SP 4-286-001

SERVICE PROGRAM

Transmission Oil Cooler (TOC) replacement for certain Xpeditor trucks with ISX engines.

This Service Program provides instructions to obtain replacement parts and replace the TOC on certain ACX-cab Xpeditor trucks equipped with Allison® transmission retarders. Program Expires: May 15, 2014

Figure 1

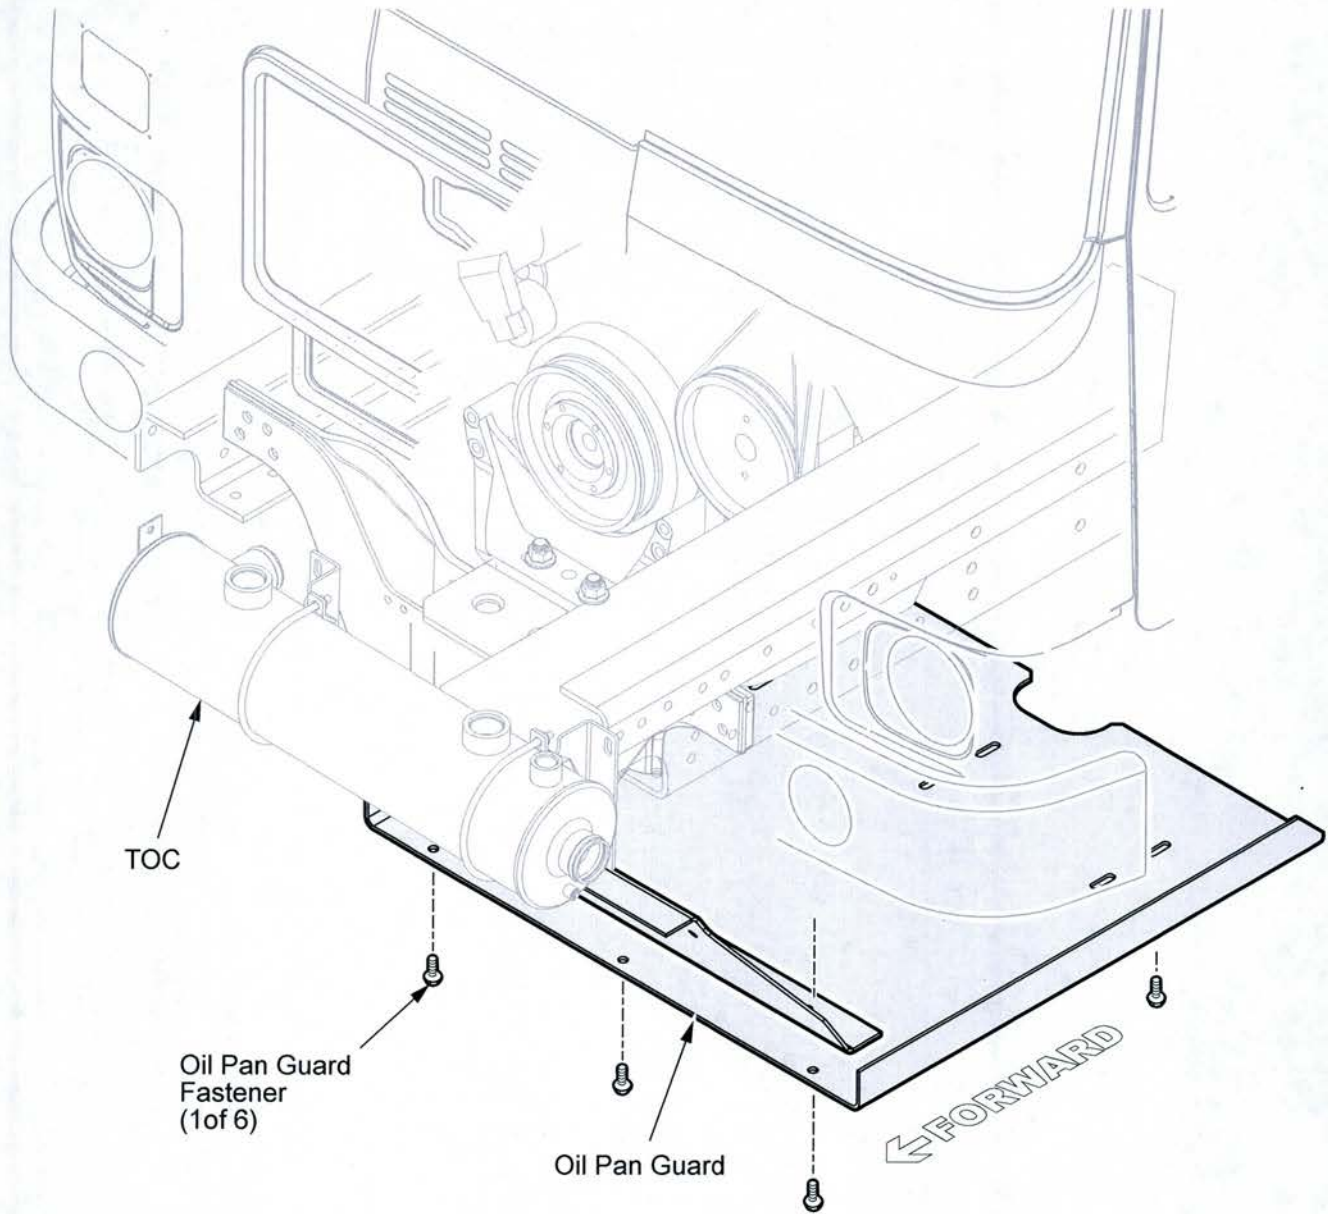
4. If equipped with an oil pan guard (skid plate), remove the 6 fasteners and set aside (fasteners and oil pan guard) for reinstallation (see Figure 1).
5. Using a 15-gallon (57-liter) drain pan, drain the cooling system by opening the drain valve on the radiator and the drain valve on the bottom of the engine oil cooler housing. Remove the TOC drain plug to completely drain the TOC (see Figure 3).

Figure 2

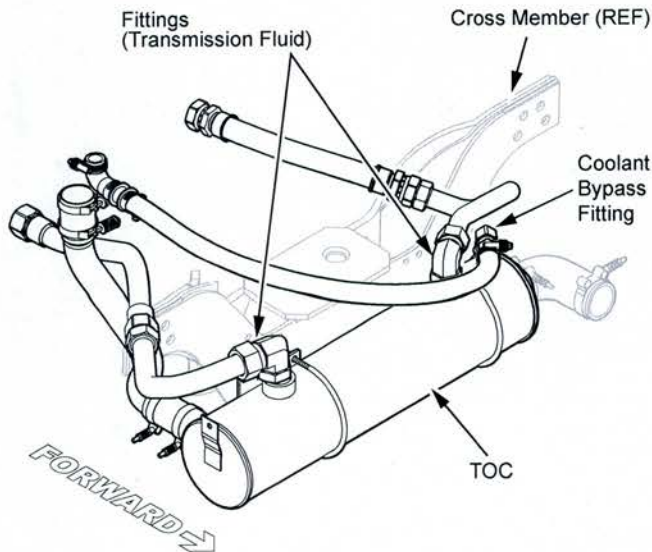
7. Remove the coolant bypass fitting from the TOC. Remove and discard the O-rings from the fitting and set the fitting aside for reinstallation (see Figure 2).

Note: Pay particular attention to the orientation of fittings, for reinstallation. Remove the O-rings from the fittings and discard (see Figure 2).

Figure 3

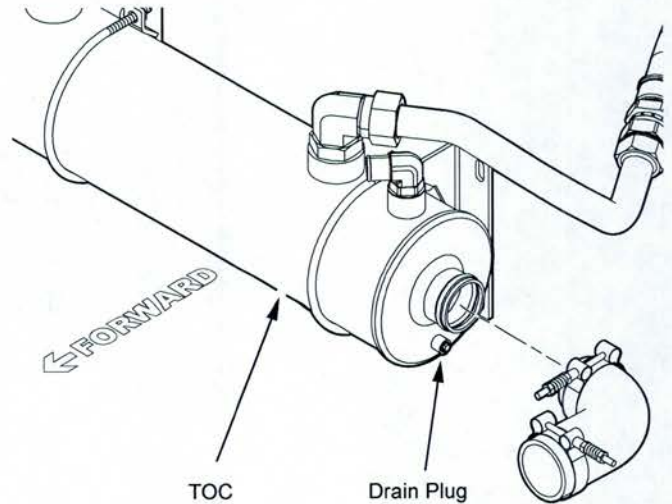
8. Position a 5-gallon (19-liter) drain pan beneath the transmission fluid pipe fittings. Disconnect the 2 transmission fluid pipes from the fittings and remove the fittings from the TOC. Remove and discard the O-rings from the fittings and place the fittings aside for reinstallation. Discard the captured transmission fluid (see Figure 3).

Figure 4

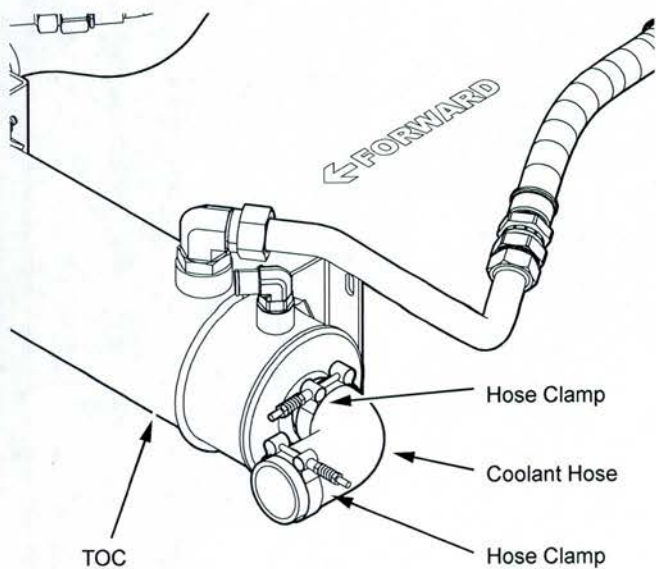
9. Disconnect the coolant hose (see Figure 4).

Figure 5

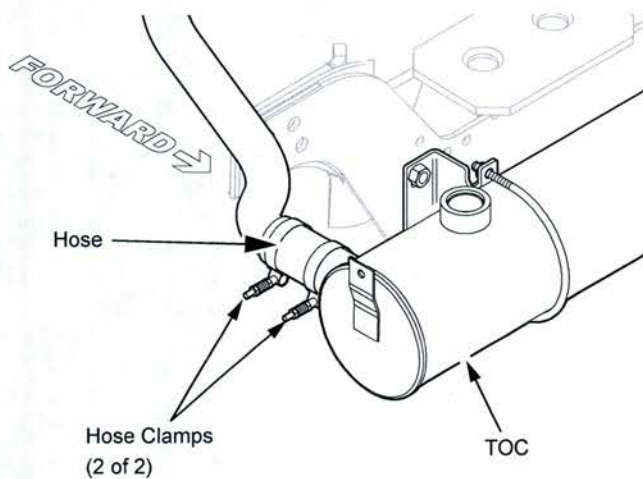
10. Loosen the clamps and remove the coolant hose (see Figure 5).

Figure 6

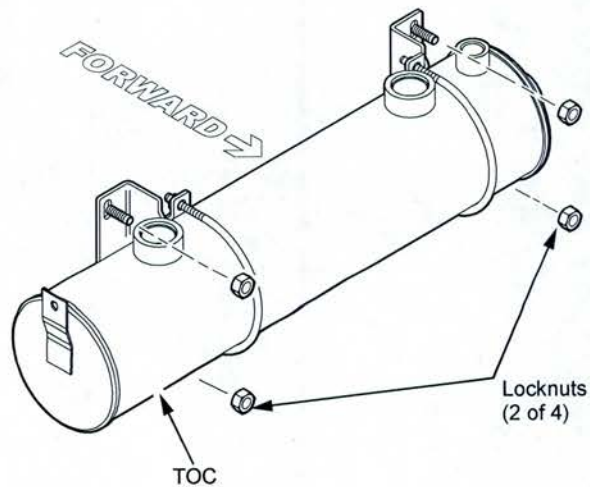
11. Remove the 4 fasteners securing the TOC to the cross member and discard the fasteners (see Figure 6).
12. Remove the TOC and discard.

Figure 7

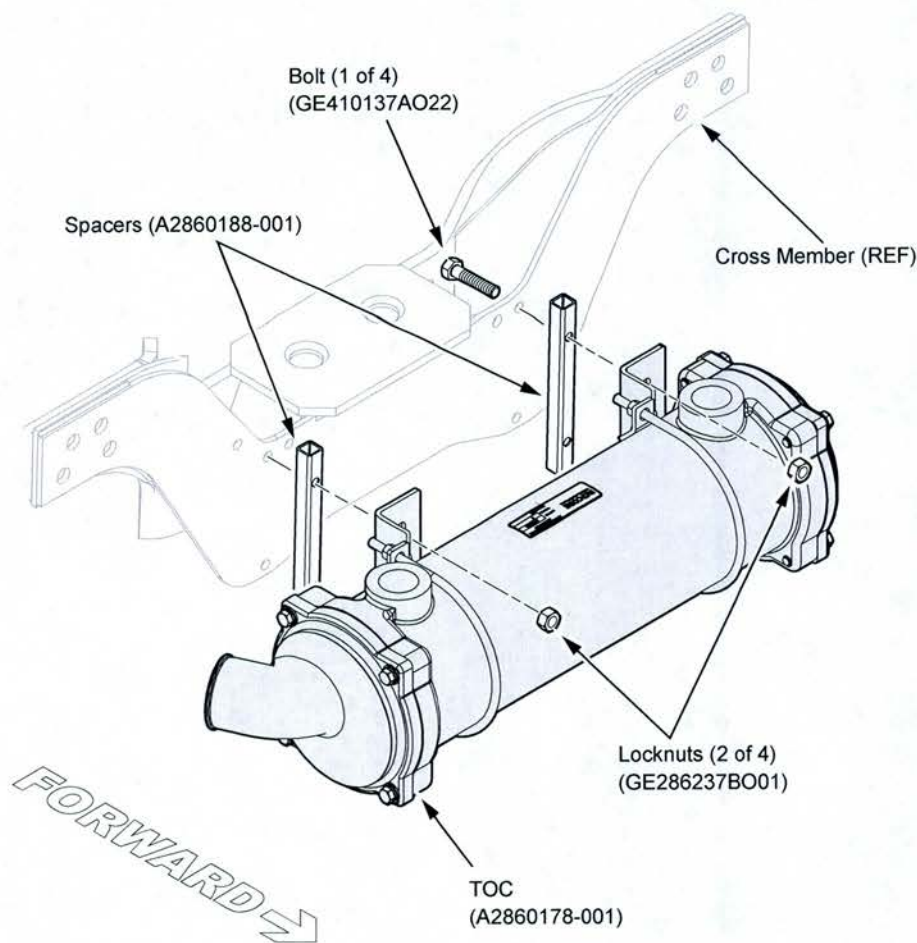
13. Position the 2 spacers (A2860188-001) to the cross member and hold in place with 4 bolts (GE410137AO22) (see Figure 7).
14. Install the new TOC (A2860178-001) over the 2 spacers and bolts. Install the 4 locknuts (GE286237BO01). Tighten to 45 ft-lb (61 N-m) of torque (see Figure 7).

Figure 8

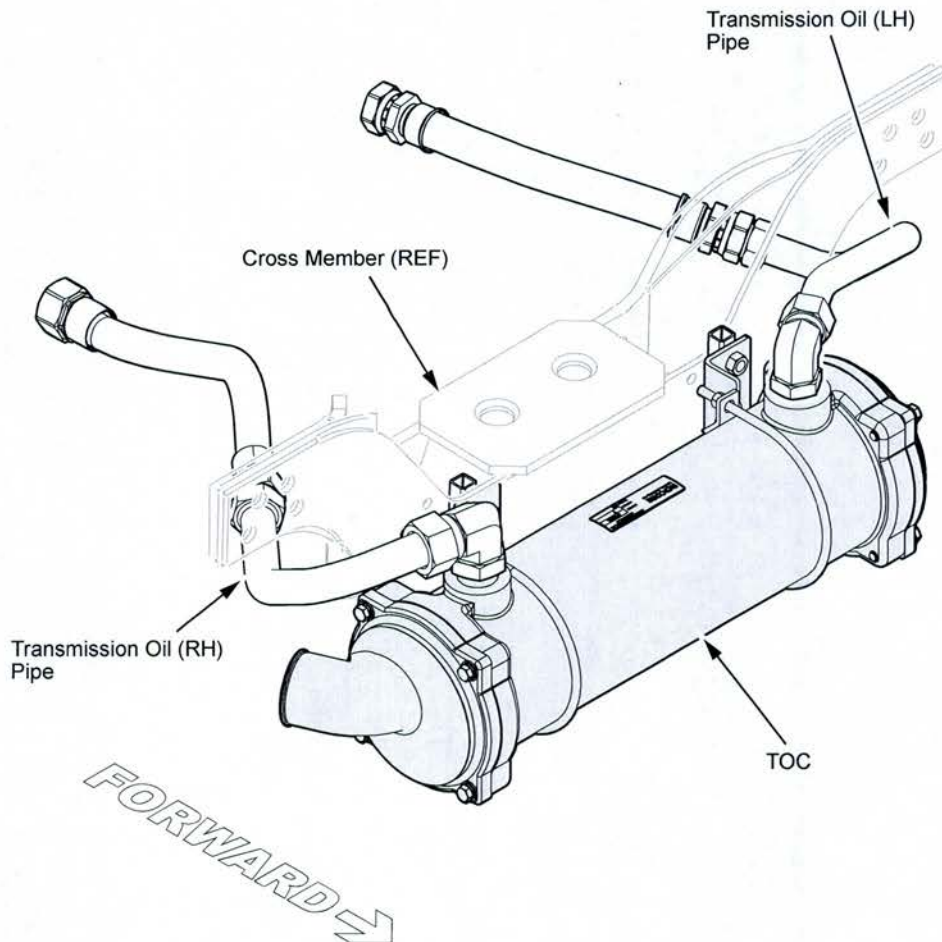
15. Locate the transmission pipe fittings which were set aside in step 8. Install 1 SAE O-ring (GZ250017-003) to each of the fittings leading to the TOC and 1 facial seal O-ring (GZ250017-004) to each of the fittings leading to transmission oil pipes. Install the fittings

into the new TOC; then, connect the TOC pipes (RH/LH) to the fittings. Orient the fittings as noted during removal in step 8. Tighten to 150 ft-lb (203 N-m) of torque (see Figure 8 and Figure 10)

Figure 9

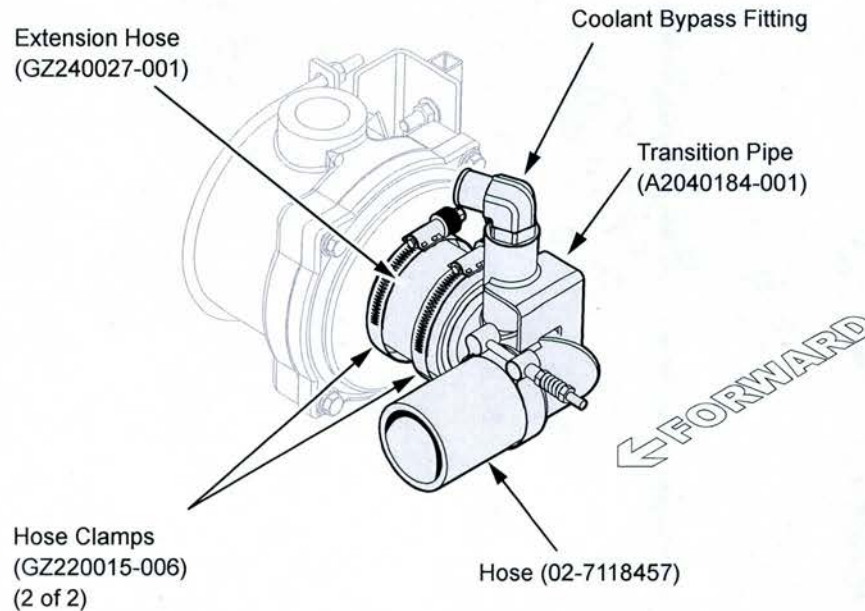
16. On the LH side of the TOC, install the extension hose (GZ240027-001) and 2 hose clamps (GZ220015-006) (see Figure 9).
17. On the LH side of the TOC, install the transition pipe (A2040184-001) onto the extension hose and tighten the 2 hose clamps to 60 In-lb (7 N-m) of torque (see Figure 9).

18. On the coolant bypass fitting, that was set aside in step 8, install 1 SAE O-ring (GZ250017-001) to the fittings leading to the TOC and 1 facial seal O-ring (GZ250017-002) to the fittings leading to

the coolant bypass hose. Install the fitting onto the transition pipe; then, connect the coolant bypass hose to the fitting. Tighten to 85 ft-lb (115 N-m) of torque (see Figure 9 and Figure 10)

Figure 11

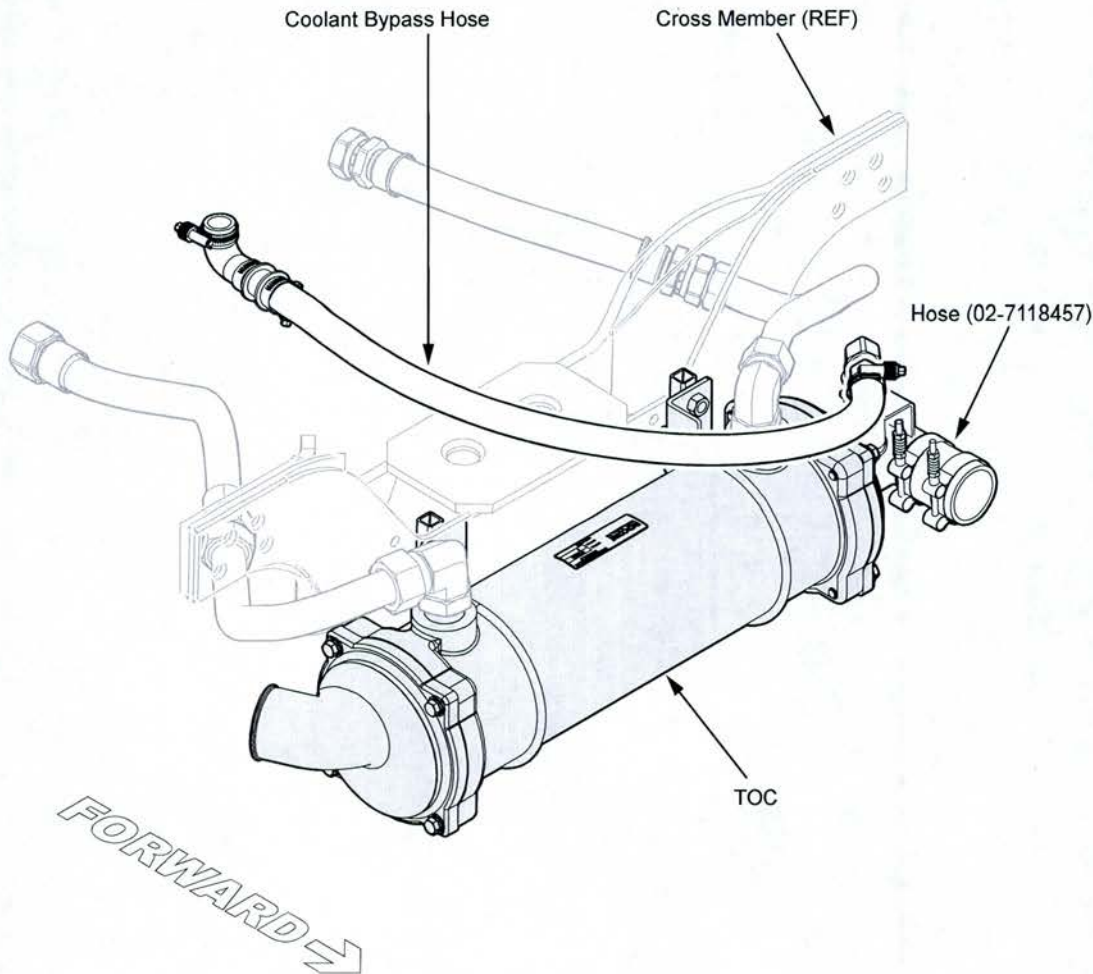
19. On the LH side of the TOC, install the hose (02-7118457) and 2 hose clamps (see Figure 11).
20. On the RH side of the TOC, using 2 hose clamps (GZ220015-006), install the elbow (A2040183-001). Tighten the hose clamps to 60 In-lb (7 N-m) of torque (see Figure 12).
21. Install the coolant pipe (A2040185-001) onto the elbow (see Figure 12).
22. Check for damaged hoses and loose or damaged hose clamps. Replace as required.
23. Check the radiator for damage and/or buildup of dirt. Clean and replace as required.
